REMEDIAL ACTION PLAN
BENTON BURN SITE
ESCONDIDO, CALIFORNIA

**FINAL REMEDIAL ACTION PLAN
BENTON BURN SITE
SWIS NO. 37-CR-0008
ESCONDIDO, CALIFORNIA**

**COMMENTS ON DRAFT REMEDIAL ACTION PLAN, MARCH 12, 2009 BENTON
BURN DUMP SITE, ESCONDIDO, CALIFORNIA
DTSC LETTER OF APRIL 3, 2009**

SOURCES: Ninyo & Moore, 2007		EXISTING COVER SOIL THICKNESS MAP BENTON BURN DUMP		
	20 0 20 40 Feet 	CREATED BY: CL	DATE: 10-06-09	FIG. NO:	
SCALE: 1" = 40' (1:480) SCALE CORRECT WHEN PRINTED AT 11X17		PM: RKS	PROJ. NO: 17326074.10003	2

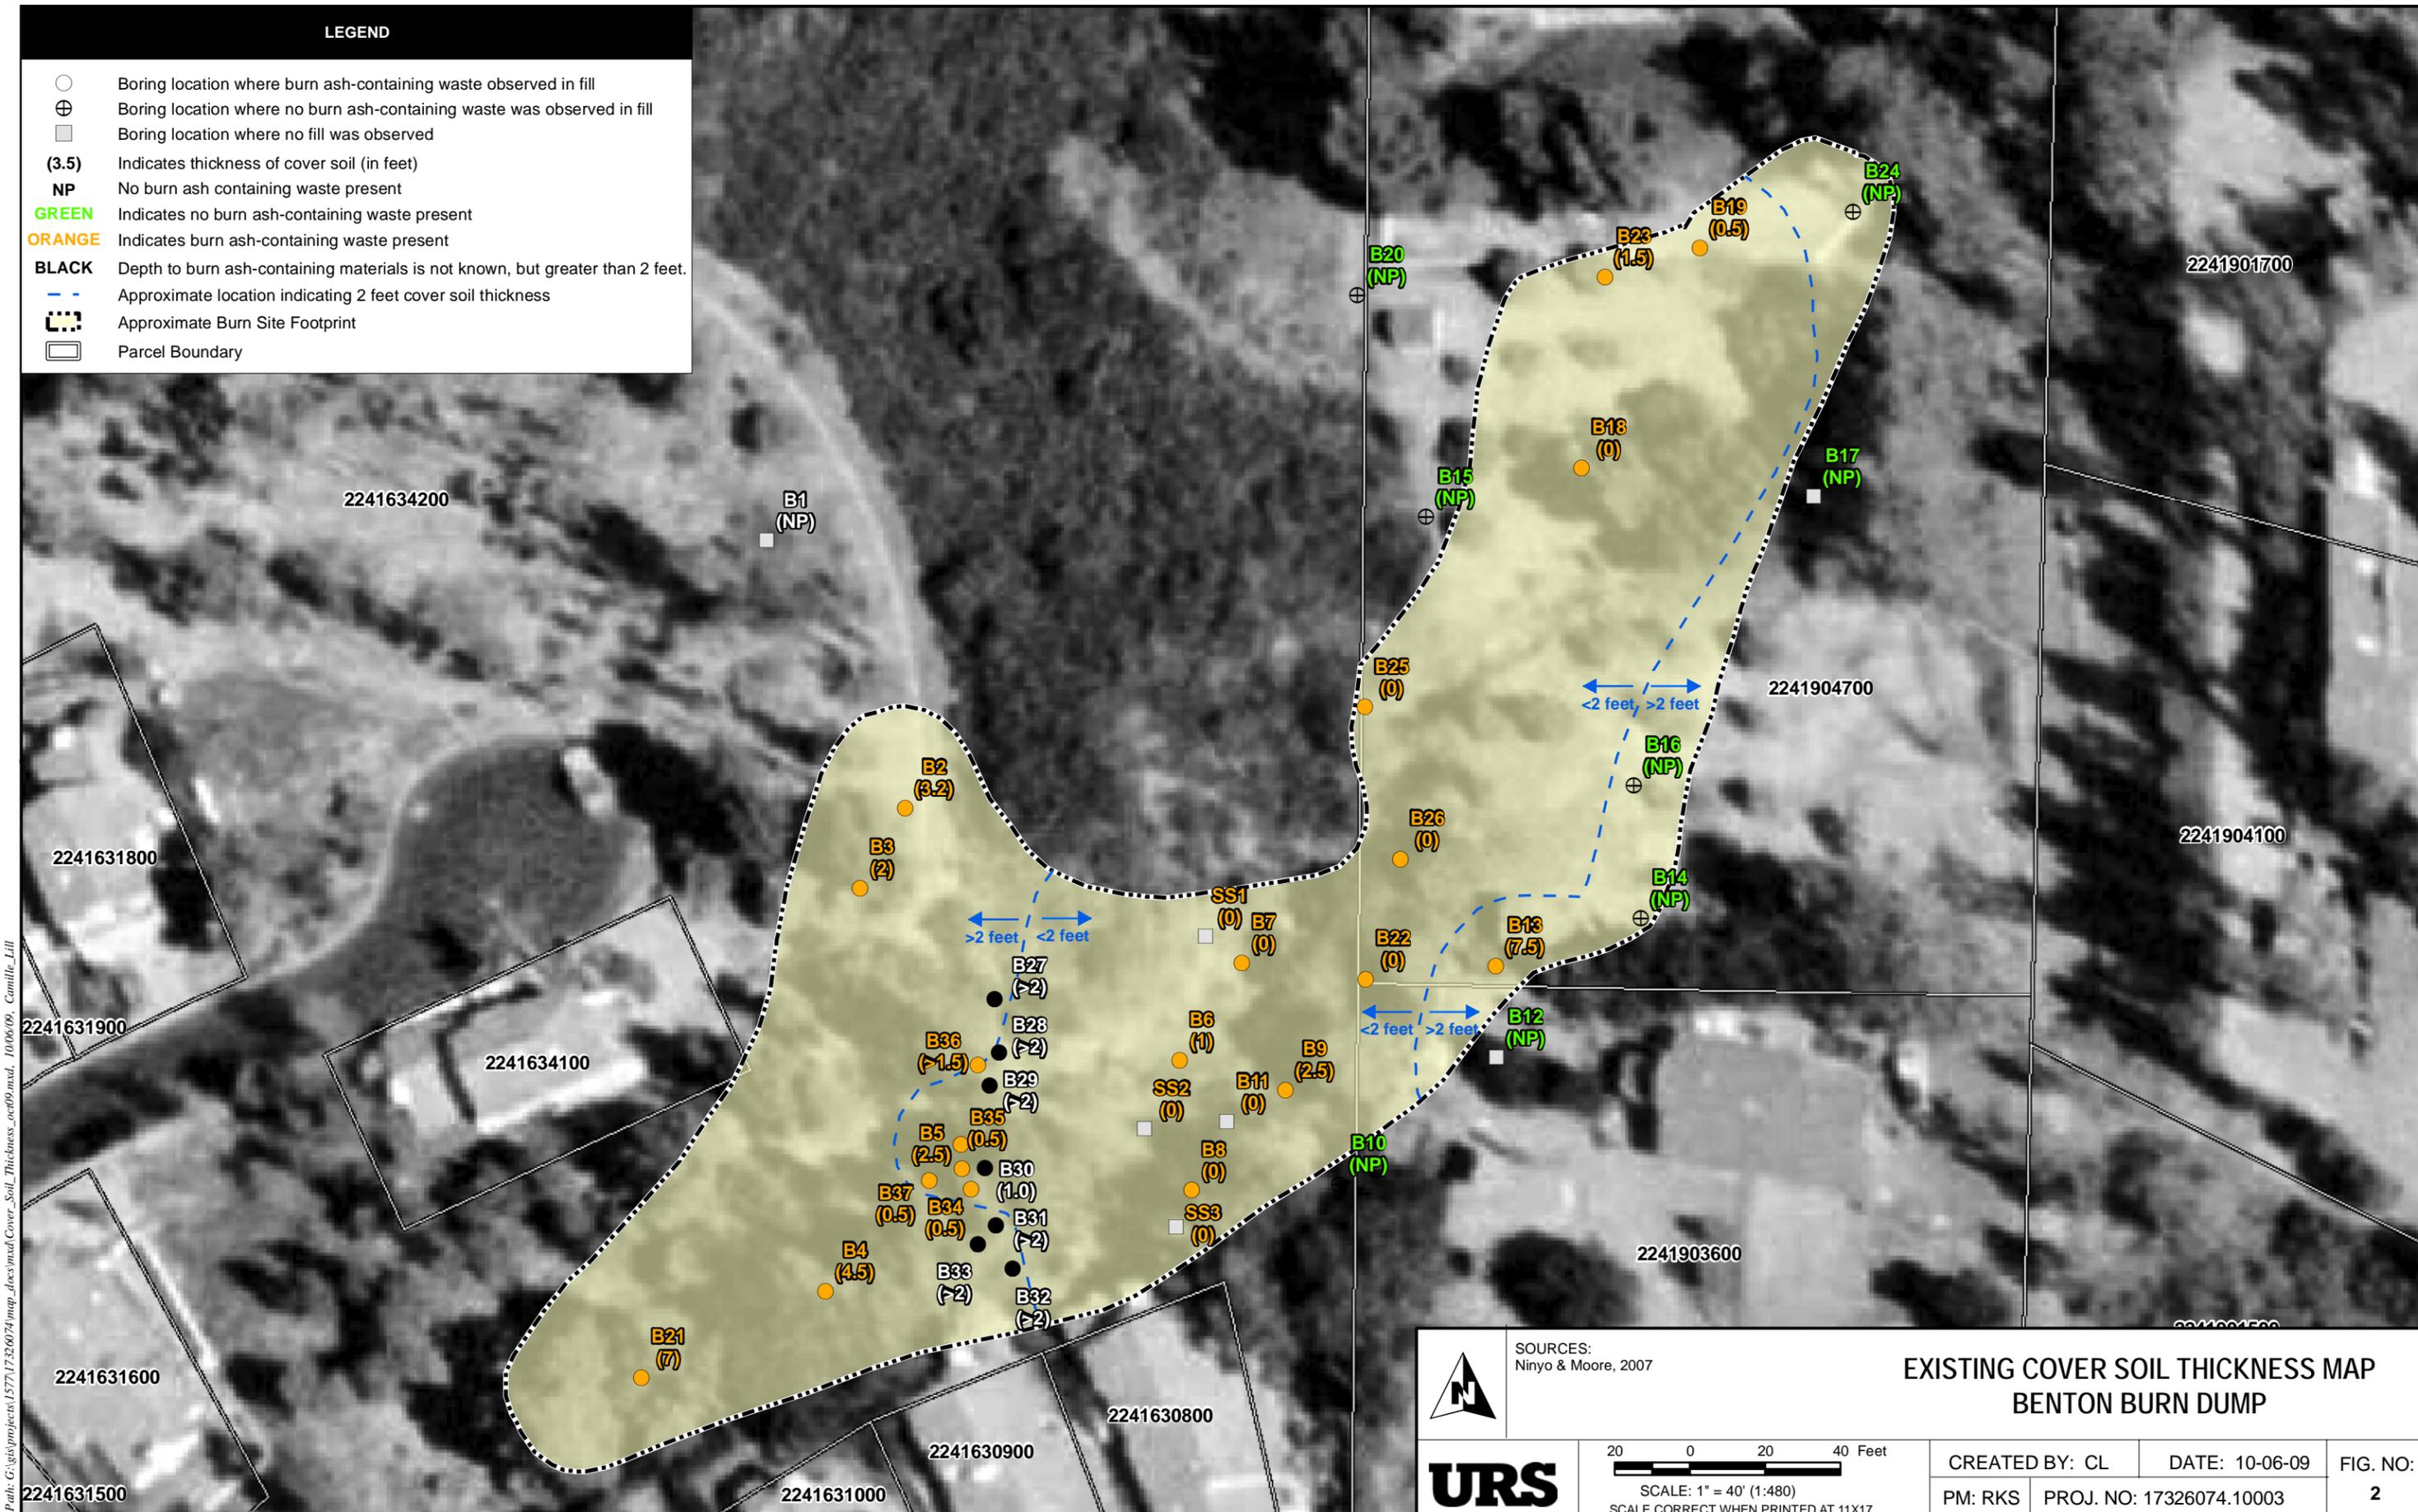
DEPARTMENT OF TOXIC SUBSTANCES CONTROL	
COMMENTS	RESPONSE
<p>3. We note that additional sampling is proposed to further delineate the extent of the burn ash-containing wastes and determine whether the wastes are hazardous. We recommend that the results be included and addressed in the final RAP since the area of proposed excavation and capping may change based on the sampling results.</p>	<p>The additional sampling was conducted in May 2009 and the results are included in the Final RAP in Section 2.4. The additional sampling was conducted to identify whether lead is present in soil within 2 feet of the ground surface at concentrations above the cleanup objective in the western portion of the burn site footprint. The objective was not specifically to identify if the soil is hazardous. A copy of the laboratory analytical report has been included as Appendix A.</p>
<p>4. We note that the parcel number (APN 224-190-42) identified in Section 1.1.1 is not the same as that listed in the Executive Summary. Also, please identify parcel number 224-190-47 on the figures. We note that parcel number 224-190-52 is shown, but this is not one of the three mentioned in the text.</p>	<p>The APN has been corrected and is included on the figures.</p>

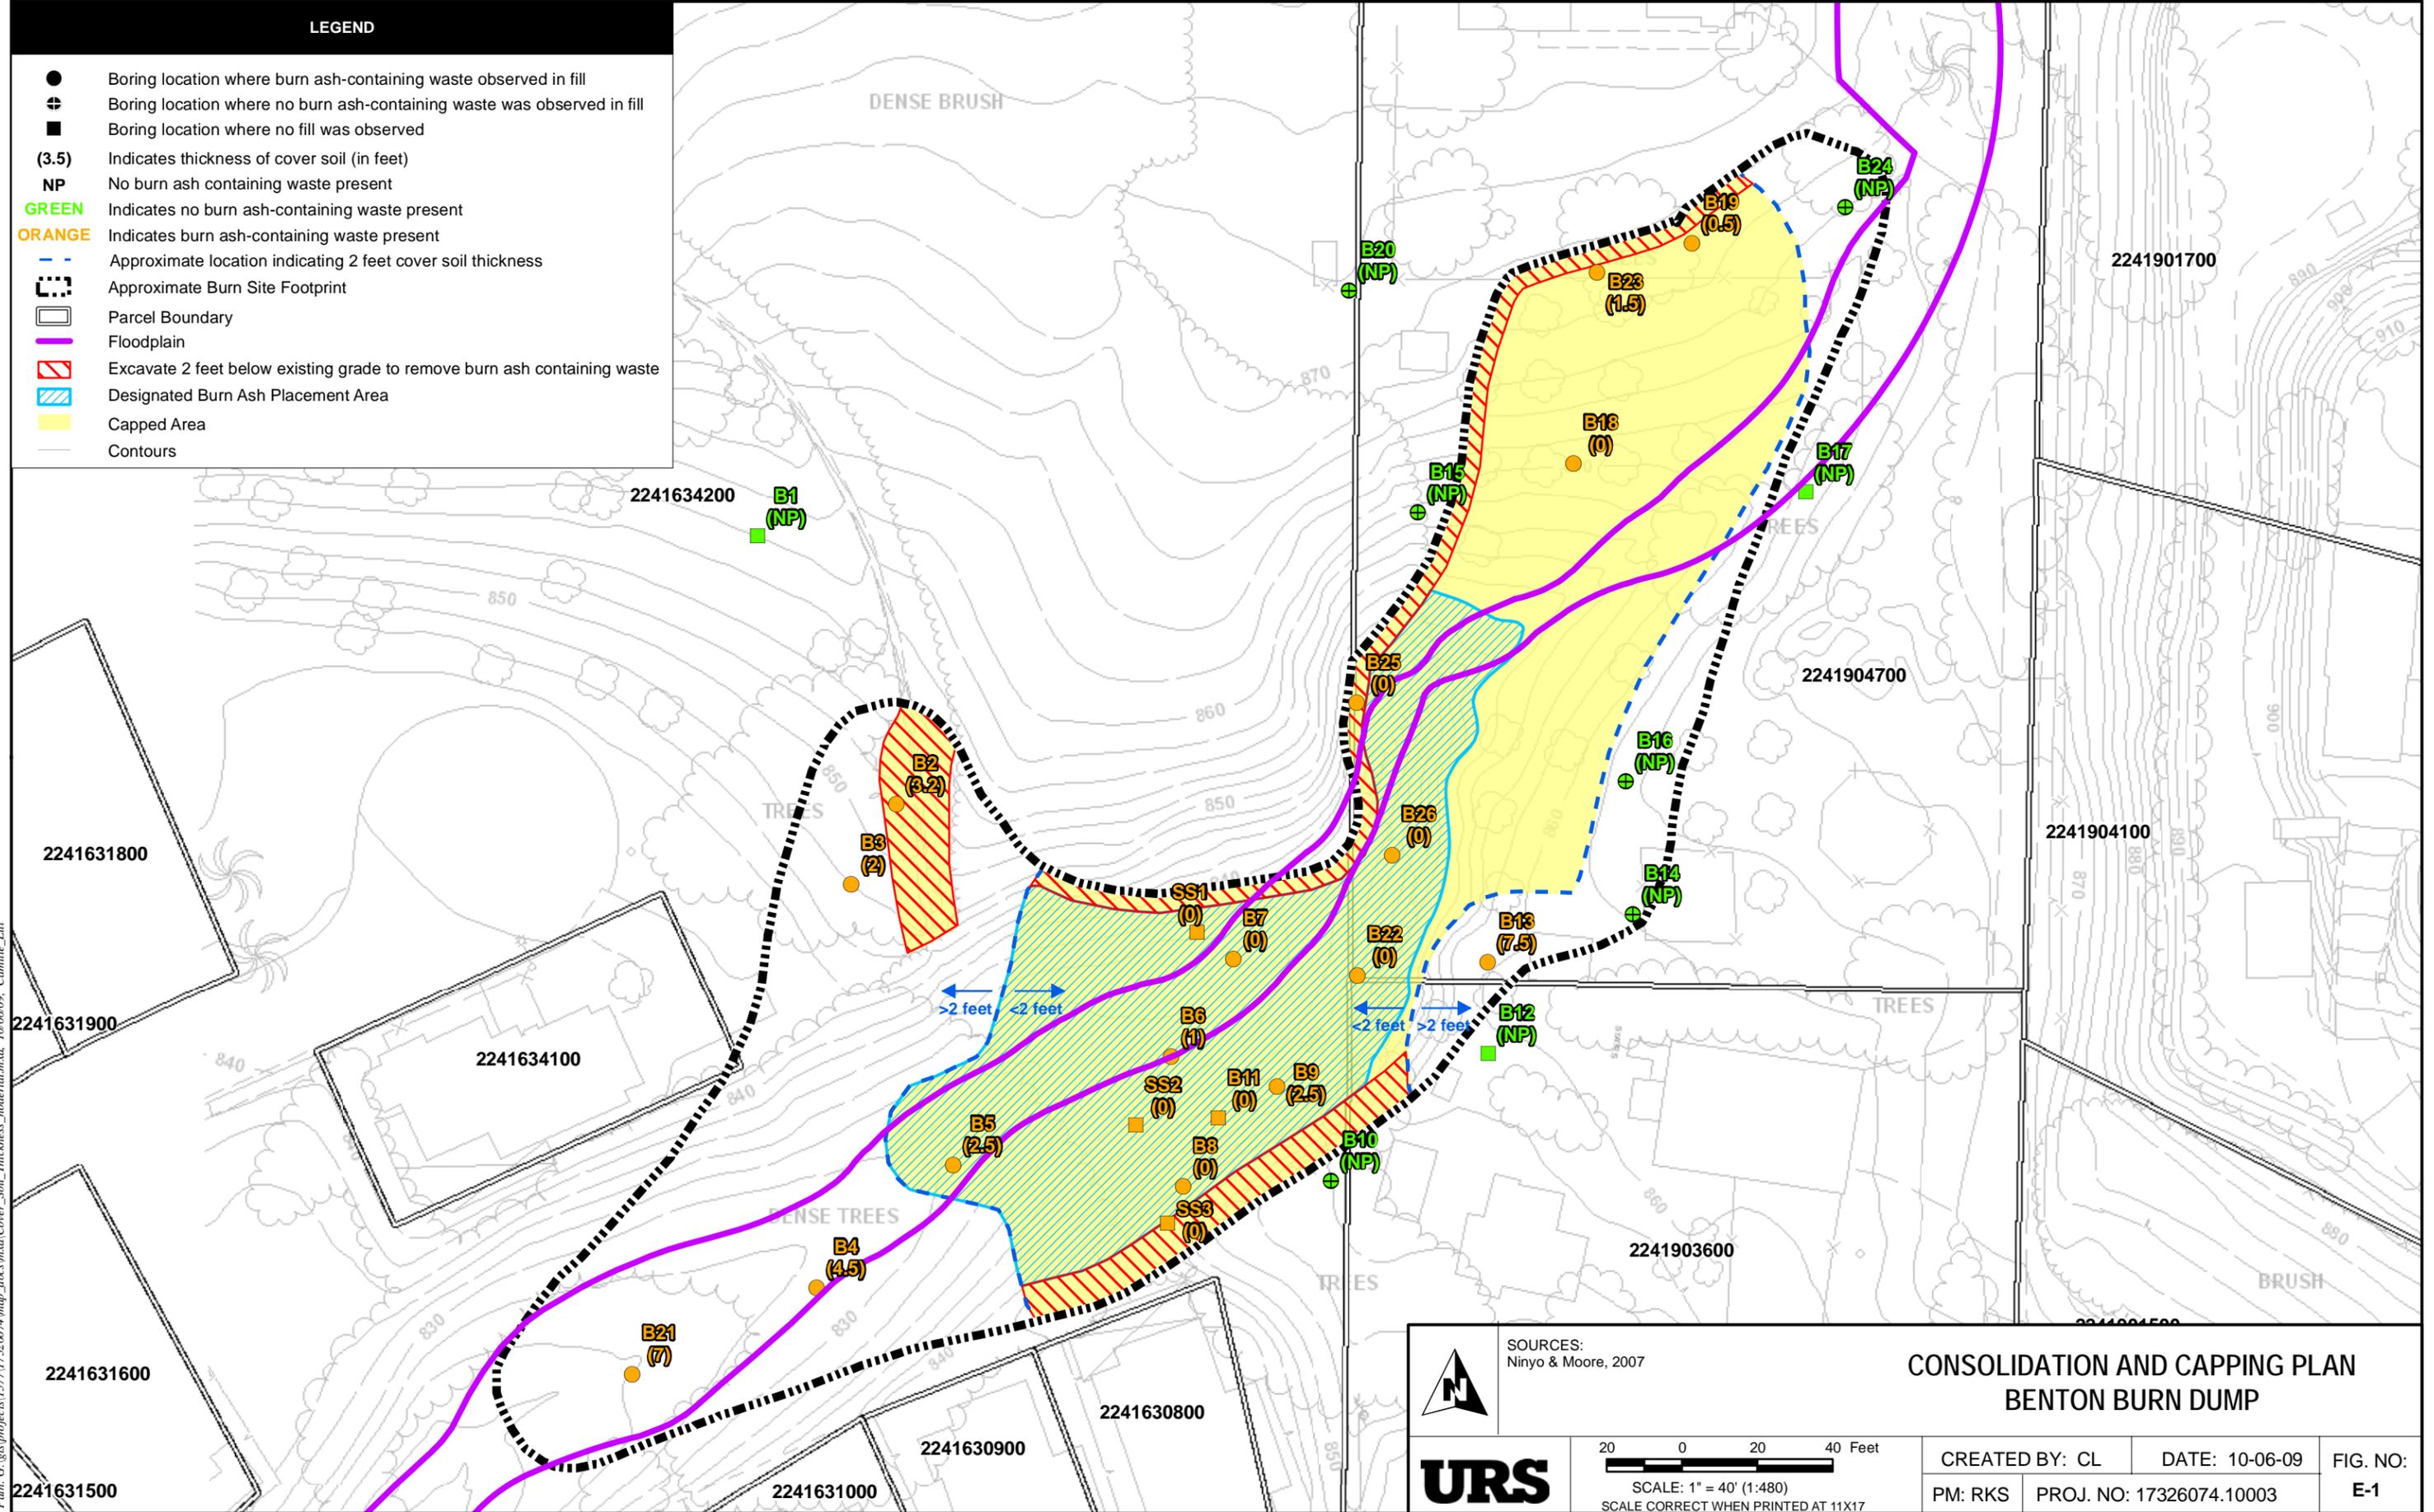
DEPARTMENT OF TOXIC SUBSTANCES CONTROL	
COMMENTS	RESPONSE
8. We recommend that the burn ash-containing wastes not be placed and capped within the 100-year flood plain.	Burn ash containing materials are already present in this very limited area that drains a very small watershed (approximately 60 acres). Placement of a geotextile and gravel in this area will limit the potential for burn ash to be mobilized during infrequent storm events. The condition of the site will be monitored by the County LEA following implementation of the remedial alternative in accordance with Title 27. If erosion of the cap or a breach is identified, it will be repaired.
